TENDER ADDENDUM

Design, Supply, Installation and Commissioning of Radio Communication System SS007

ADDENDUM No. 5

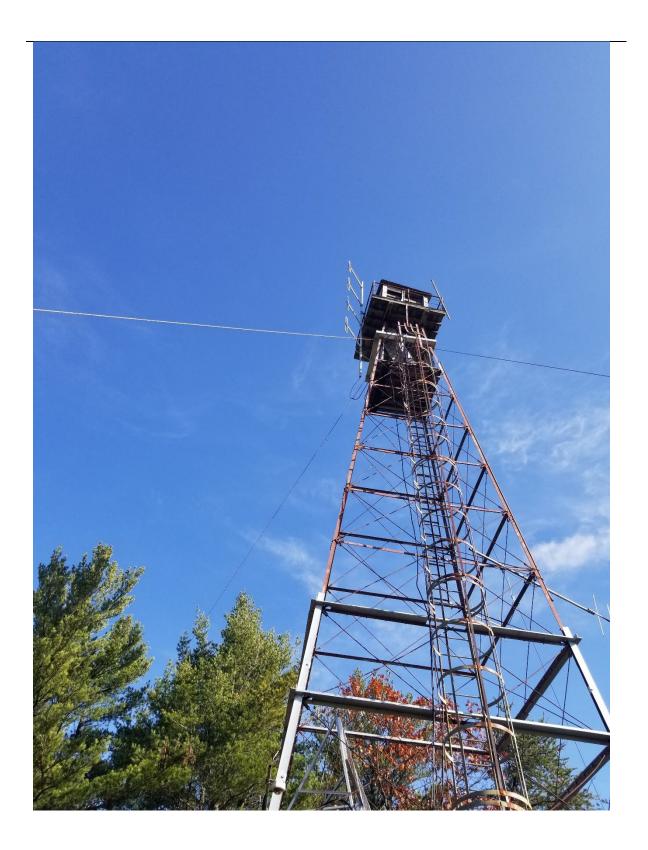
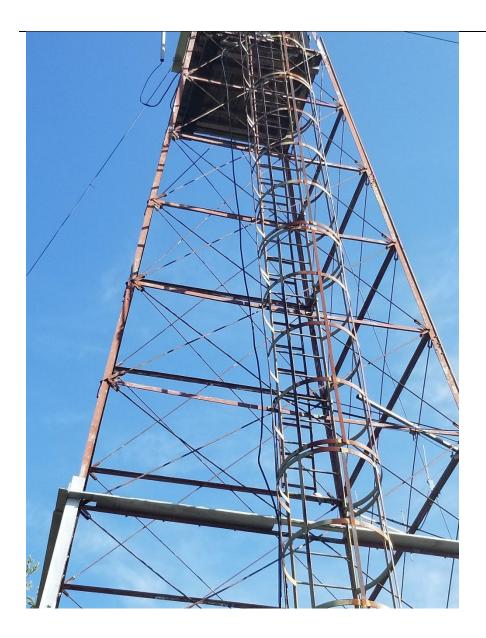
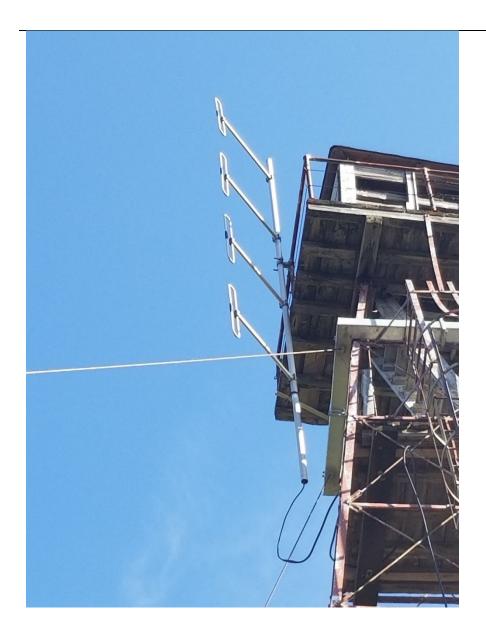
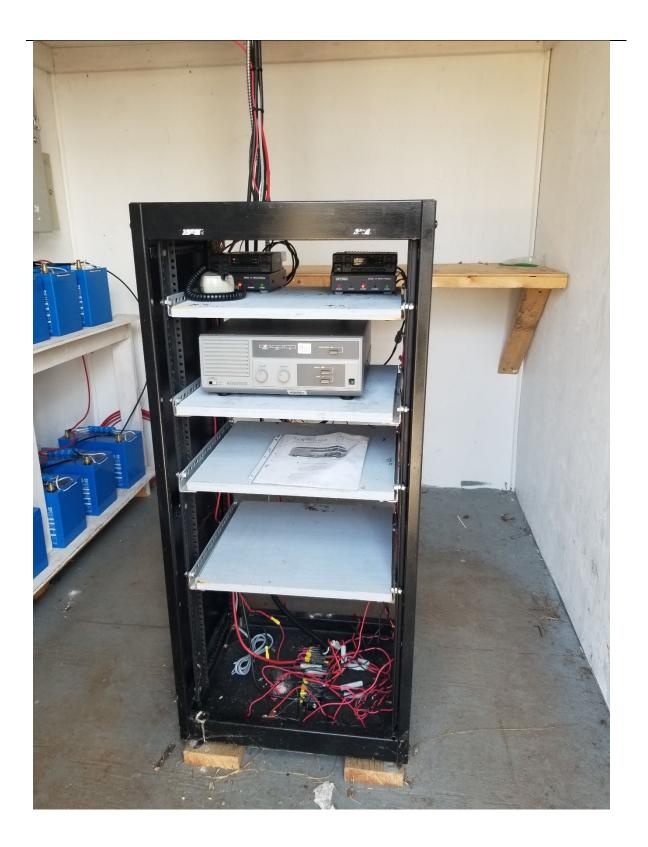
Addendum #2, Answer 5

This answer states the NCC will "advise specific equipment that is to be removed from the Fire Tower."

Question: So that Bidders can accurately estimate the removal costs for this site which are to be included as part of our Bid, please provide the list of equipment that is to be removed

For purposes of Bidder's prices, to be verified with Contractor after contract award):

- a) 4 element exposed dipole & mounting hardware
- b) 2.3 cm (7/8 in) RF transmission line
- c) Radio Repeater
- d) RF Filters
- e) All interconnecting cabling.

Batteries, solar panels and solar panel controllers are excluded for purposes of the Bidders' pricing.
